SERVICE BULLETIN

Classification:	Reference:	Date:
RS16-013b	NTB17-006b	August 25, 2017

2013 – 2016 ALTIMA AND 2015 – 2016 MURANO; OCCUPANT CLASSIFICATION SYSTEM RETROFIT

This bulletin has been amended. Pages 18 and 21 have been revised.
No other changes have been made. Please discard all previous versions of this bulletin.

Figure 3

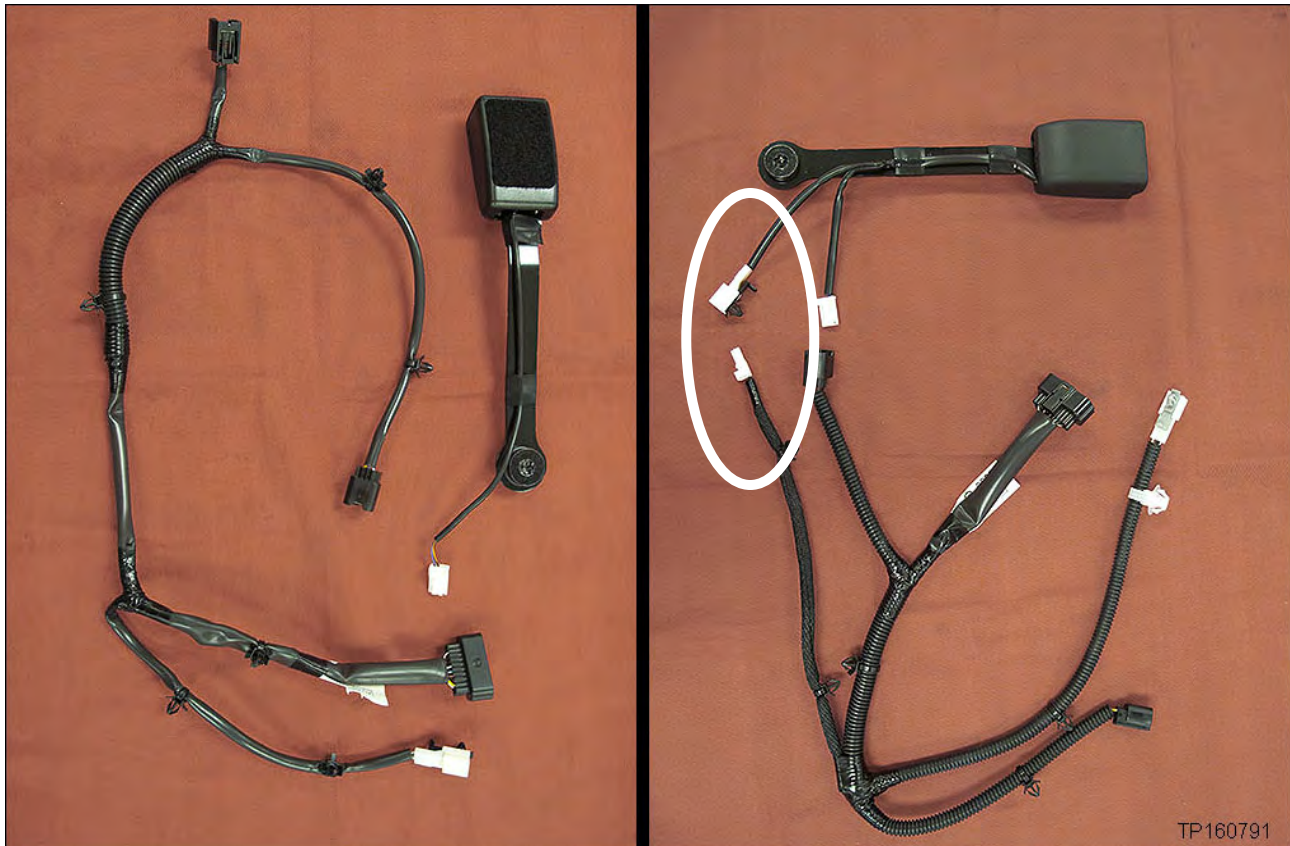
EXAMPLE

Old OCS harness and seatbelt buckle are removed.

EXAMPLE

New OCS harness and seatbelt buckle are installed

Notice the new harness and buckle have a new branch with connector
